RECEIPT DATE: 4/3/2025 **ONSITE SEWAGE DISPOSAL SYSTEM** P 5-89024

From: Oswald Jr, Woodin
Sent: Monday, October 28, 2024 10:20 AM
To: Rob Vogel
Cc: Jeremiah Reynolds
Subject: OSDS Plan Review Comments_12950 Highland Road

ONSITE SEWAGE DISPOSAL SYSTEM DESIGN PLAN

MCDANIEL PROPERTY - LOT 8
12950 HIGHLAND ROAD
HIGHLAND, MD 20777

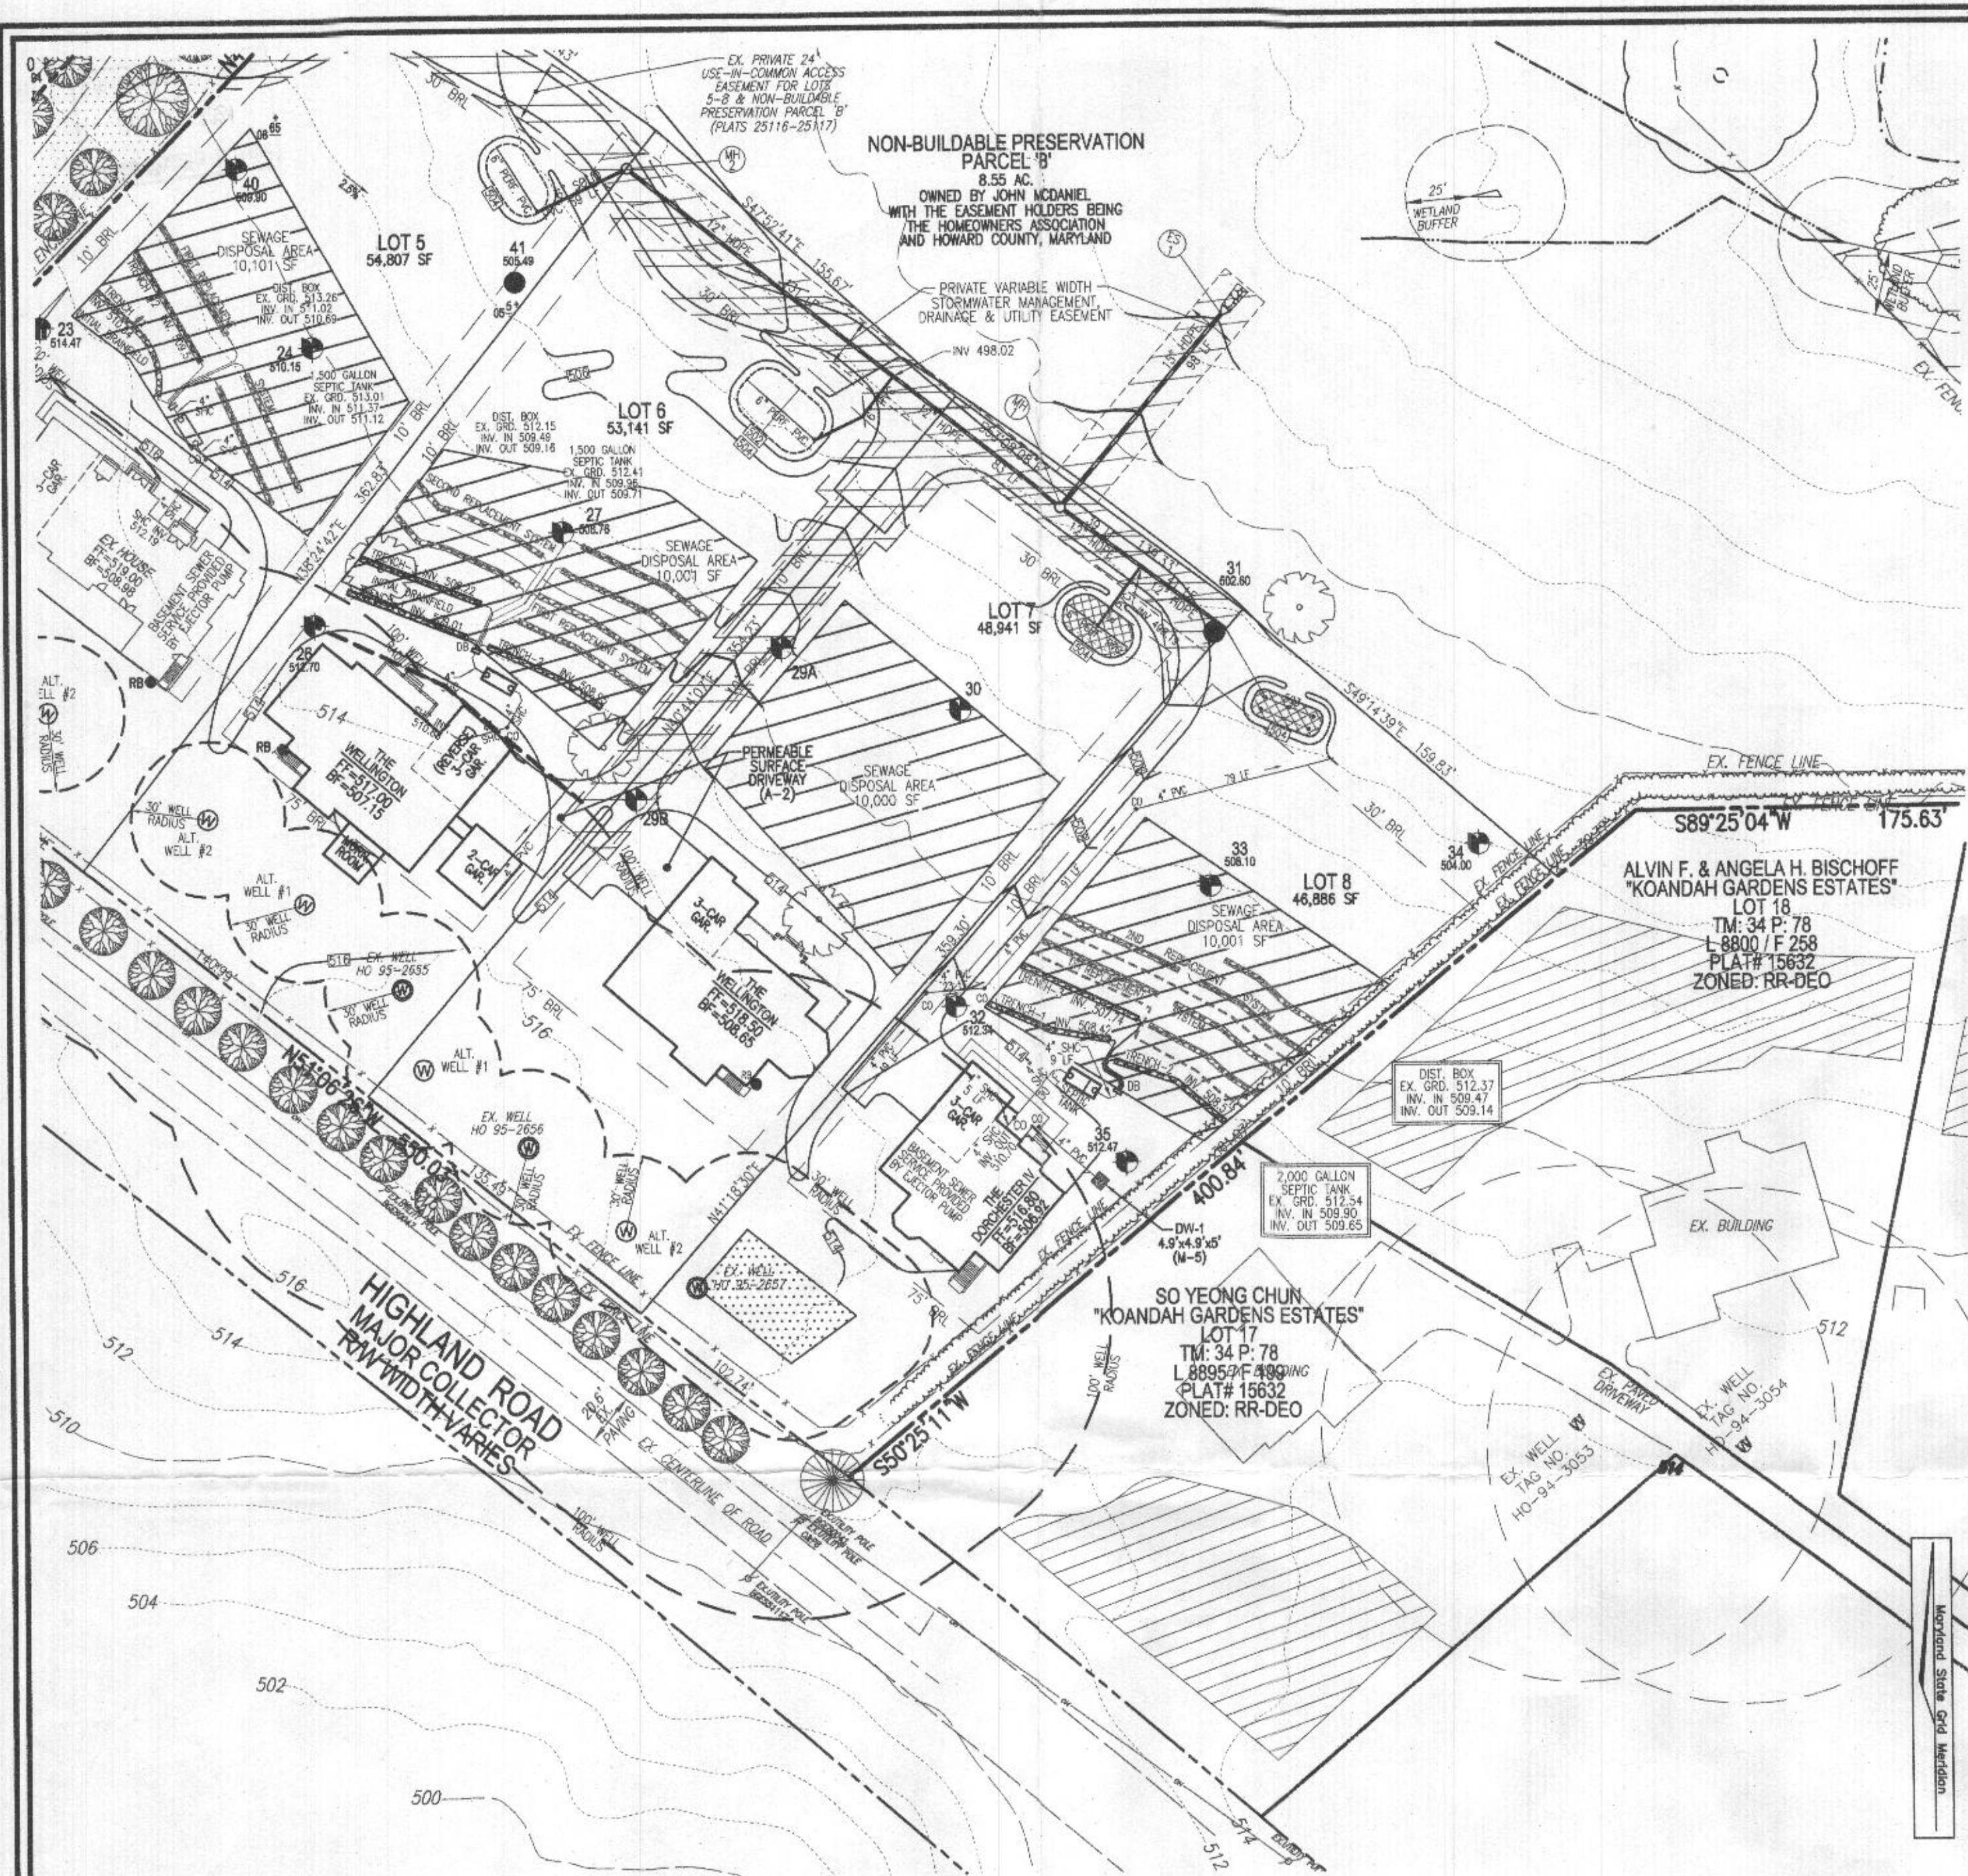
1. The set of trenches for the initial system including the 1st replacement trench while on contour have too many bends. An installer will not install the pipe as shown. Please note that the trench pipe is allowed to be a couple of inches off contour. Please revise and/or consult with an installer on this.
2. There is a 4 inch pipe that appears to start at the top of the driveway (no inlet grate shown), and ends on the back side of the driveway (no rip rap shown). Is this design correct?
property
